Assessment of Clause 4.6 request to vary building height standard

1 Overview

Figure 1: Extract from the South Elevation Plan showing the proposed residential flat building development, which is consistent with the maximum height and building envelopes approved in the Concept Plan (JRPP-15-02701 as amended), as indicated by the dashed red line.

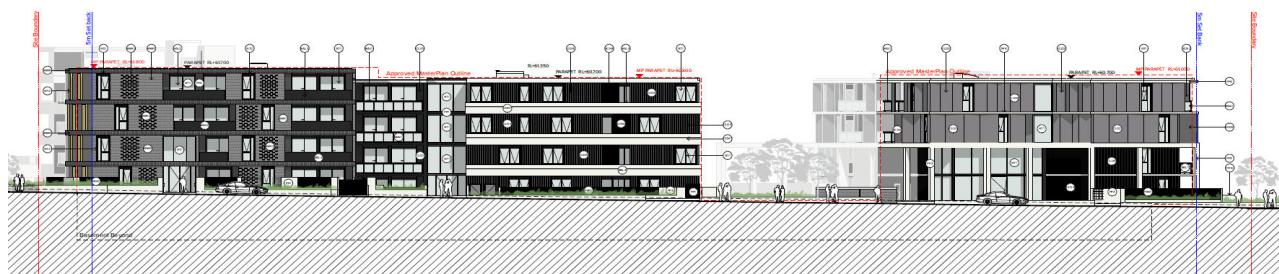
The Concept Plan (JRPP-15-02701 as modified in MOD-17-00493) approved a maximum building height limit of up to 15.4 m for this site, 3.4 m above the height permitted under State Environmental Planning Policy (Sydney Region Growth Centres) 2006 of 12 m, as shown below:
